intel® Technical Advisory

TA-0341-4

January 21, 2001

SKA4/SRKA4/SPKA4/ISP4400 Erratum Regarding 66 MHz PCI Bus Operation.

SKA4 Baseboard and MEC Block Diagram

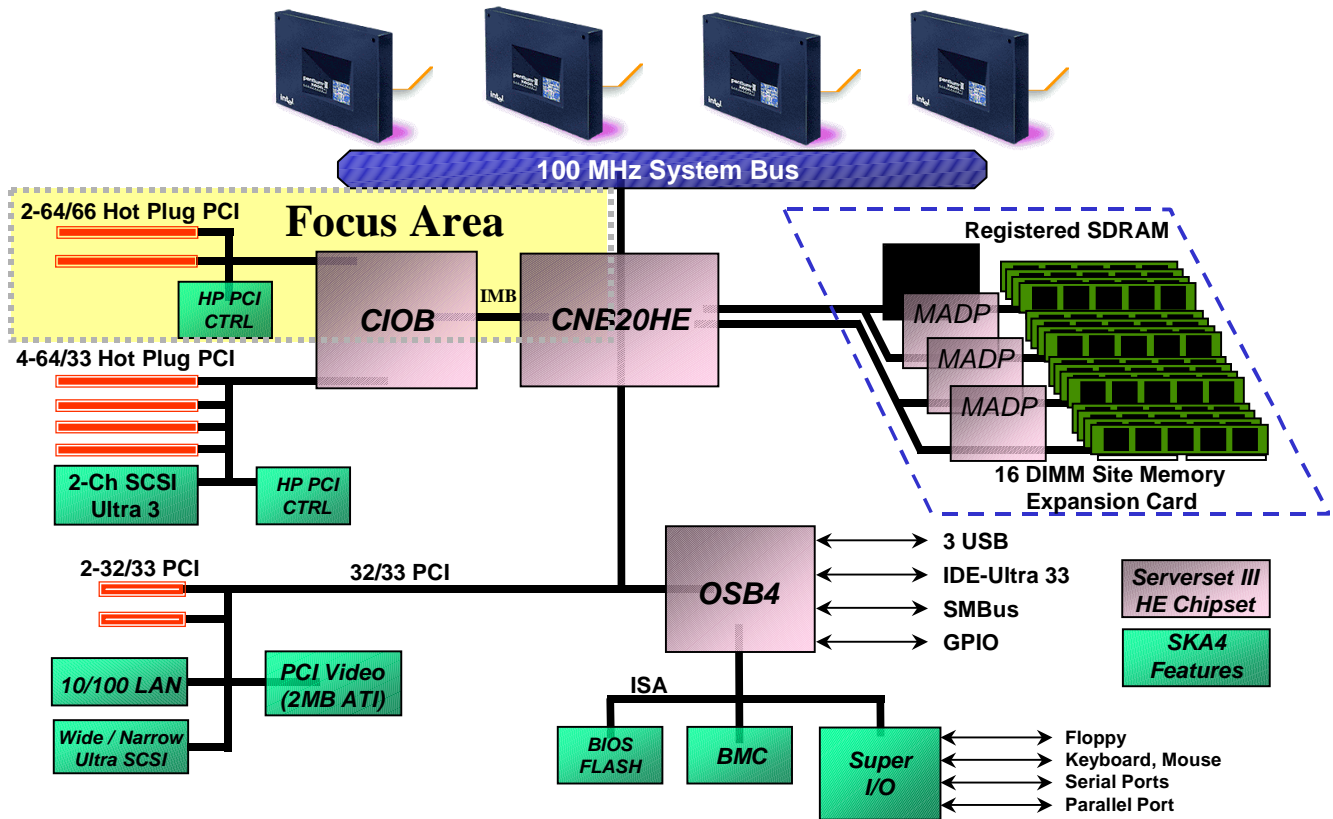
The configurations under which the IO errors could be observed are isolated only to 66 MHz operation of the two baseboard 66 MHz capable PCI slots (PCI-A) and are independent of the operating system or 66 MHz adapter used. This issue does not apply to the six 33 MHz slots (PCI-B and PCI-C) and does not apply when the two 66 MHz slots are operating at 33 MHz. Please refer to the attached *SKA4 Baseboard and MEC Block Diagram*.

As a workaround, Intel is providing a feature in BIOS that automatically configures the two 66 MHz capable PCI slots to run at 33 MHz. Implementing this workaround will ensure the two 66 MHz capable slots operate at 33 MHz even if populated with 66 MHz capable adapters. Extensive test results show that the IO error associated with the sighting is not exhibited when the two 66 MHz capable slots on the SKA4 server board are operated at 33 MHz. Note that workarounds are not fully validated until root-cause is determined.
